B SECTION

<p>Certificate of Authorization CH2M Hill Canada Limited (ON) No. 1441 Expiry: April 30, 2006</p>	B.M. ELEV.	<p>Frederickson Cooper ARCHITECTS</p>	<p>A Geo International Ltd. Company</p>	ENGINEER'S SEAL	<p>THE CITY OF WINNIPEG WATER AND WASTE DEPARTMENT ENGINEERING DIVISION</p>	
	DESIGNED BY: EL			CHECKED BY: AP		ORIGINAL SIGNED BY: D. KRUGER
	DRAWN BY: RL			APPROVED BY: AHL		2005/10/28
	SCALE: 1:50			RELEASED FOR CONSTRUCTION BY: R. SOROKOWSKI		CONSULTANT DRAWING NO. WI-S0202
NO. REVISIONS	DATE BY	DATE	DATE	DATE	WATER TREATMENT PLANT FOUNDATIONS AND CONCRETE STRUCTURES 1 STRUCTURAL RAW WATER PUMP STATION AREA SECTION	
		2005/08/02	2005/10/28		CITY FILE NUMBER SHEET OF CITY DRAWING NUMBER 1-0601-A-90202-001-02D

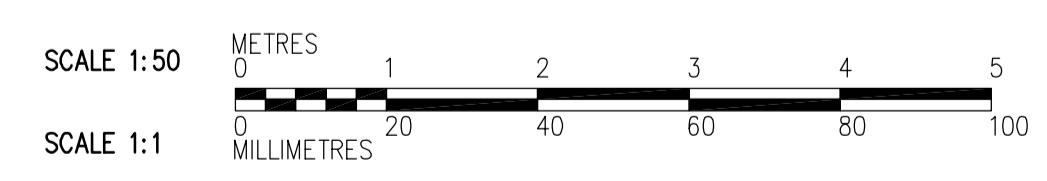
NOTES:
 1. SEE PLANS FOR SLAB REINFORCEMENT.
 2. THE MONORAIL AND BEAMS WERE INCLUDED IN REVISION 3-ISSUED FOR CONSTRUCTION, IN ERROR AND SHOULD NOT BE CONSIDER PART OF THIS B0650-2005 PACKAGE.

NOT IN CONTRACT

FOR INFORMATION ONLY - NOT IN CONTRACT
